E8363C-04 <u>S E R V I C E N O T E</u>

E8363C PNA Microwave Network Analyzers

An enhancement added to absorb vibration when opening the swing deck during hardware repair.

Figure 1

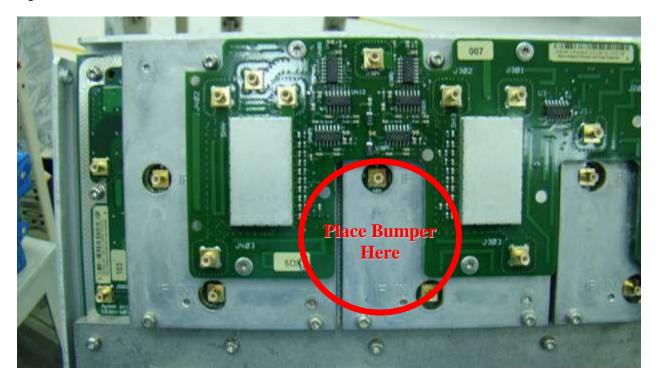
A rubber bumper – E8361-40001 is available to improve the serviceability of the instrument. This will also ensure the swing deck well separated from other nearby assembly.

- 1. Go to http://na.tm.agilent.com/pna/documents.html.
- 2. Click on the appropriate Service Guide.
- 3. When the PDF of the Service Guide is displayed, look at the bookmarks in the left column. Expand the Contents section by clicking on the plus sign next to its bookmark.
- 4. Scroll through the Contents section bookmarks to locate "Repair & Replacement Procedures."
- 5. Click on the title/hyperlink for the section "Receiver Deck."
- 6. Follow the instructions in the subsection "Raising and Lowering the Receiver Deck."
- 7. Once the Receiver Deck has been lower, installed the Bumper as shown in Figure 2.
